901 Harrison

Design Review Board

MACFARLANE PARTNERS & ANKROM MOISAN ARCHITECTS, INC.
DPD #3016723 / **NOVEMBER 05, 2014**

1. Architectural Concept - Slender tower

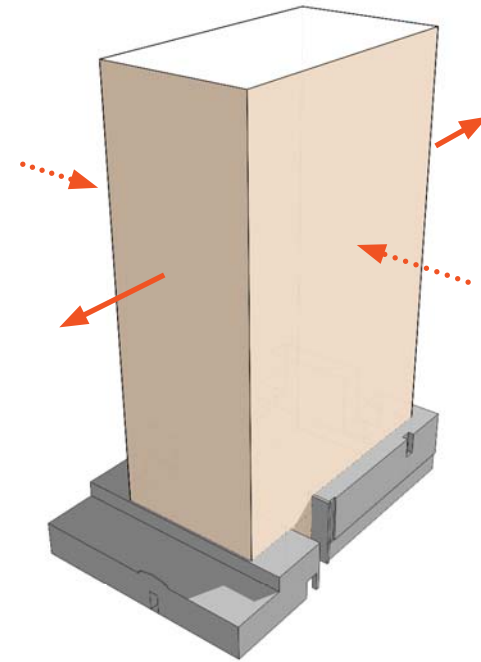
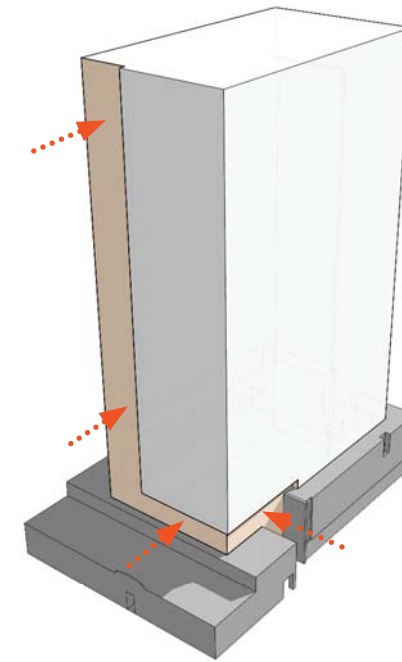
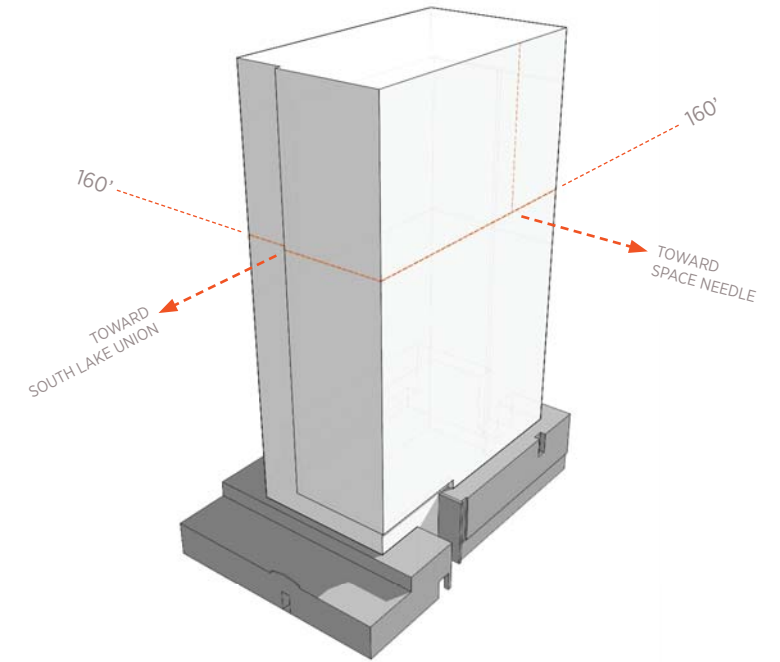
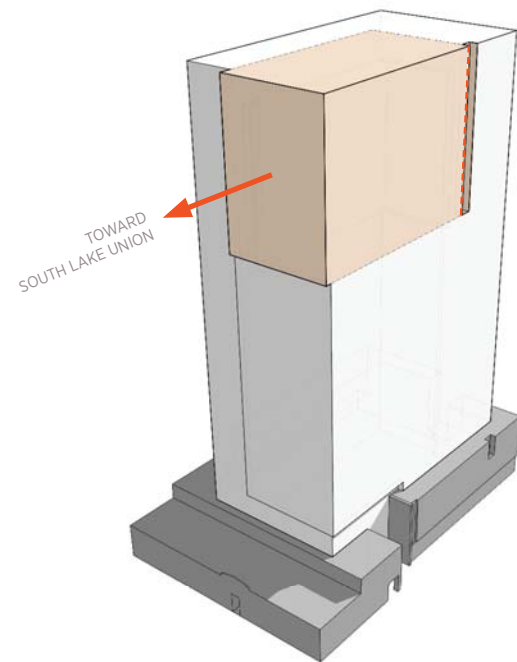
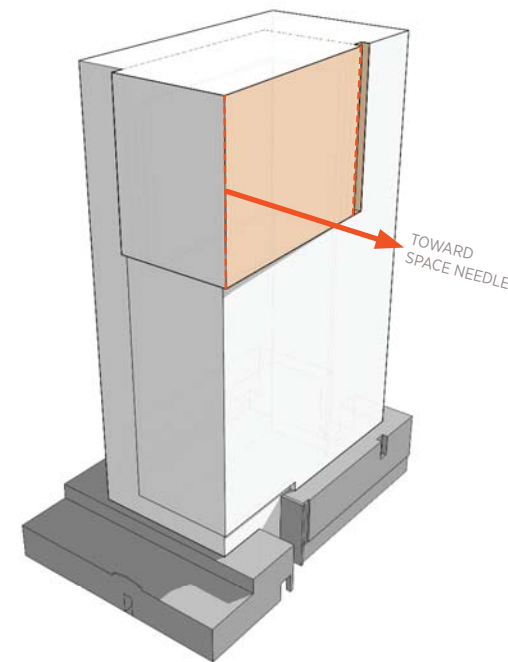
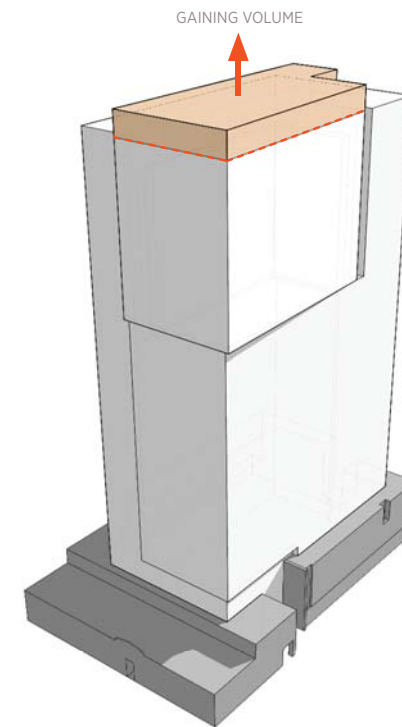
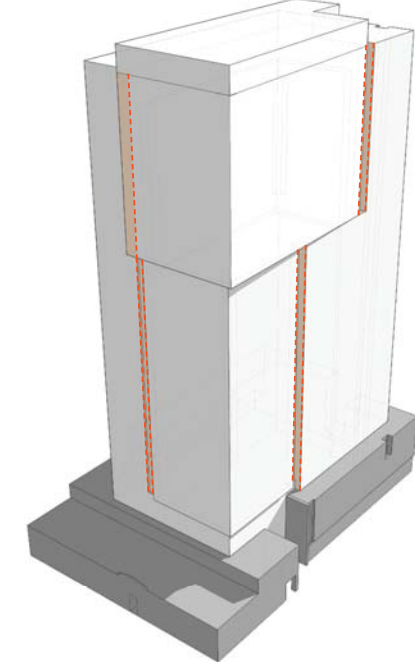
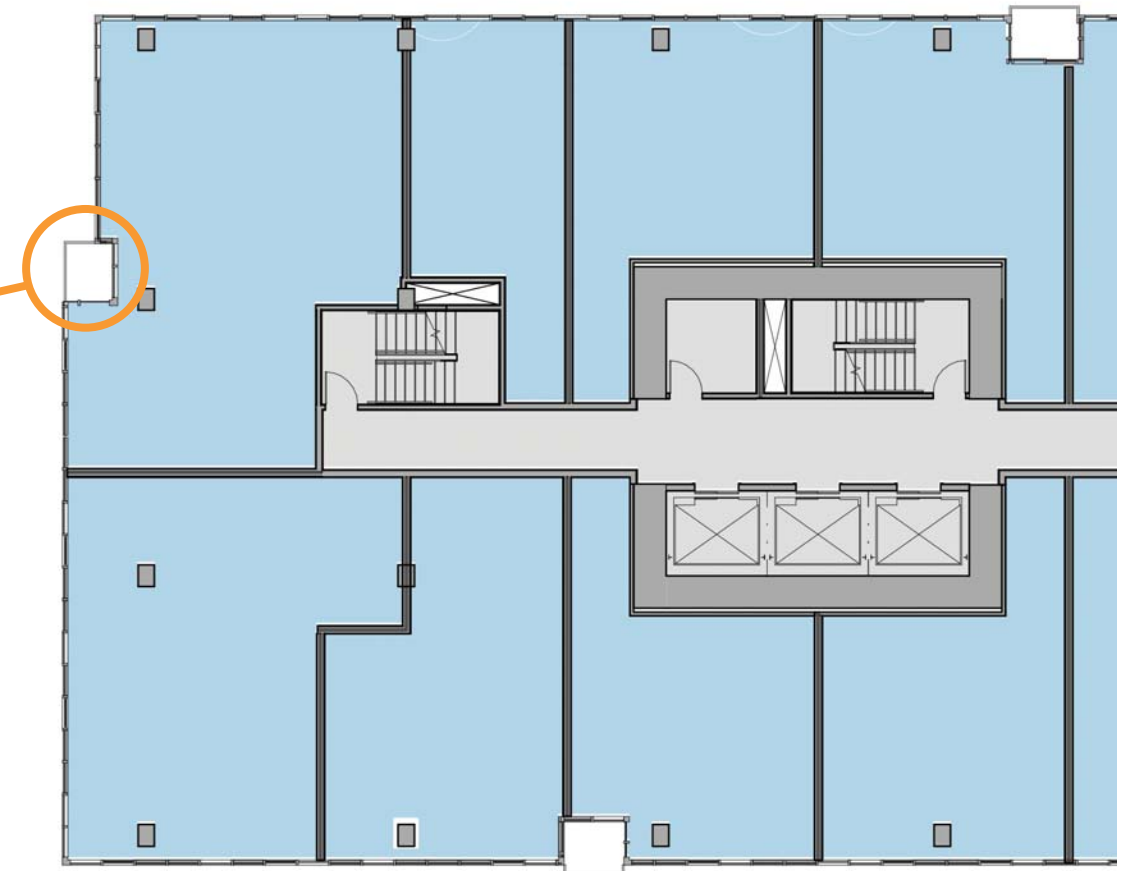
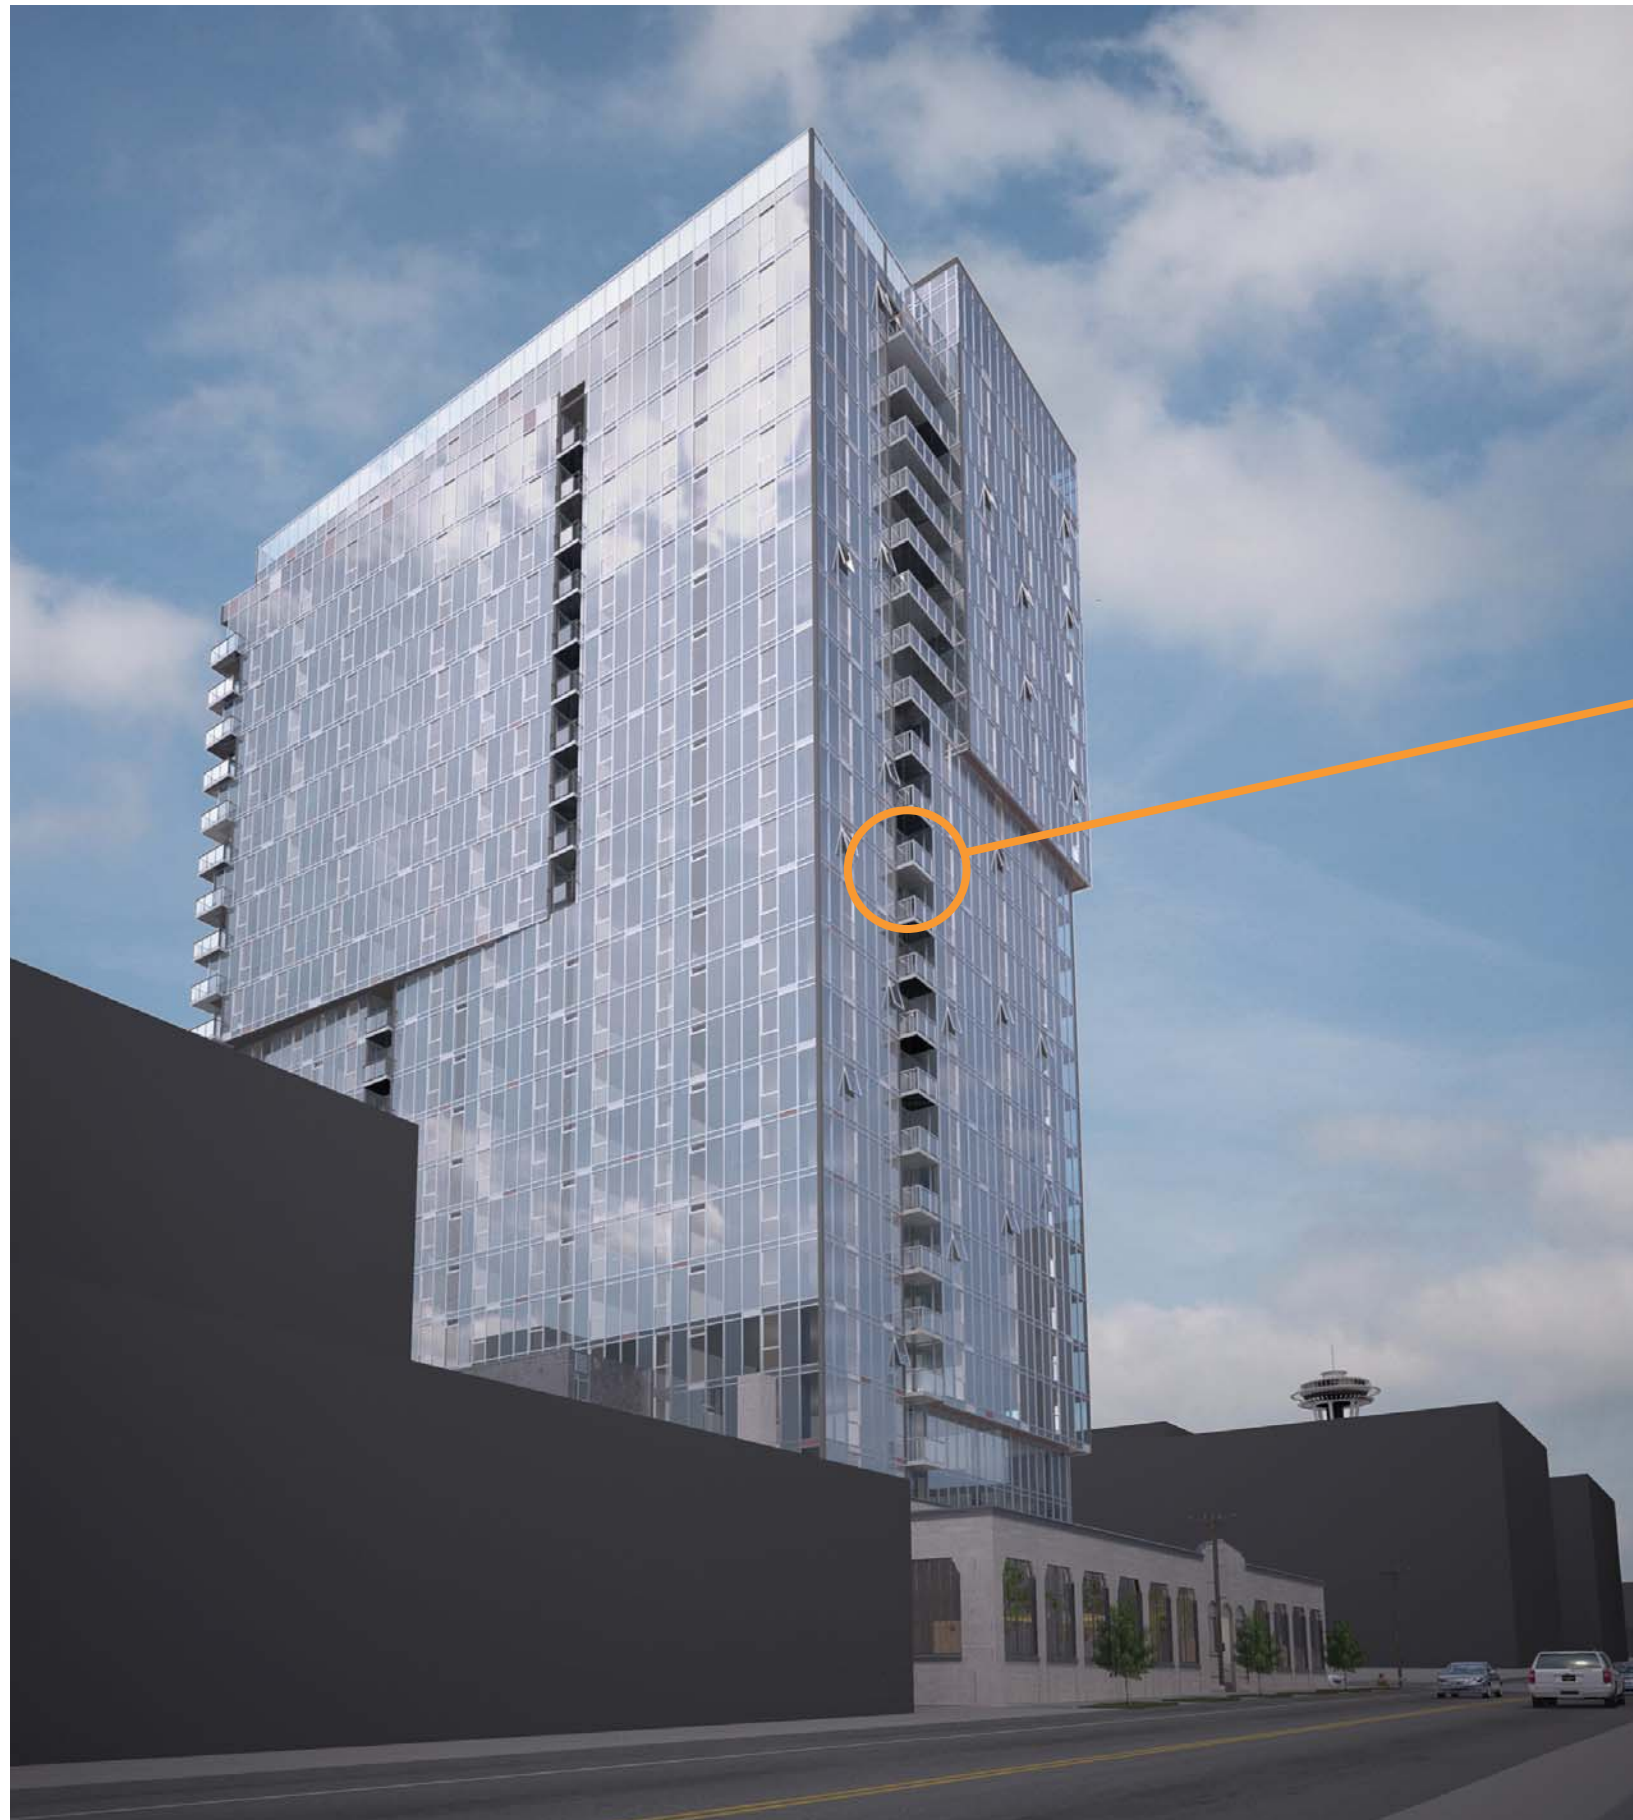
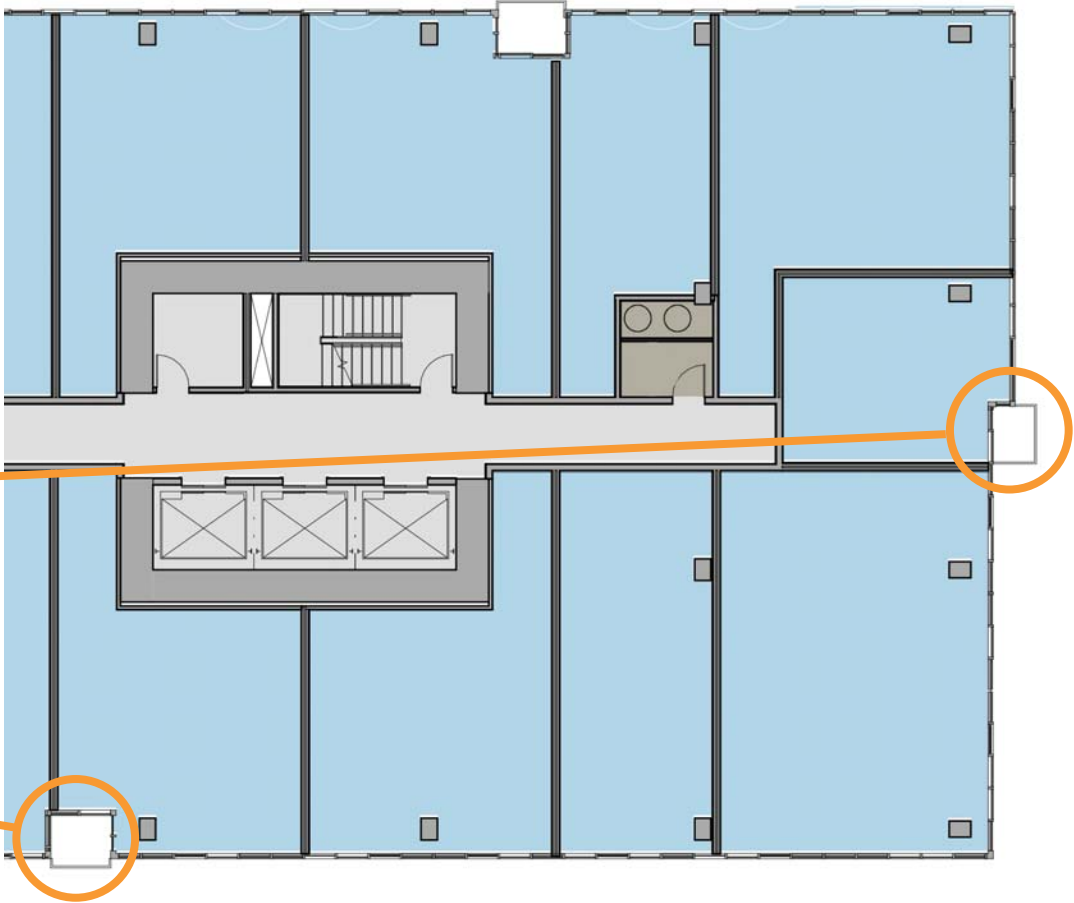
- 1a “...slender tower relates better to the context ...” (CS1.B.3, CS2.II.ii)
- 1b “.The tower should be further modulated on the north and west facades to enhance the articulation and the slender appearance of the tower...” (CS2.A.2, CS2.II.ii, DC2.A)
- 1c “The design of the podium and tower design should be integrated...respond to the context...” (DC2.B, DC2.D)
- 1d “...should consider the possibility of incorporating the existing building façade into the proposed development....” (CS3.B.2, CS3.II.ii & iv)

1 Neutral square tower volume

2 Stretched to create shallower units with greater access to daylight

3 Volume pushed back along intersection with Landmark facade

4 Recognition of view opportunities above 160'

5 Capital massing pulled toward South Lake Union view

6 Capital massing rotated toward Space Needle view

7 Amenity space occupies prime space for the new tower community

8 Strategic insertion of balconies to highlight tower massing
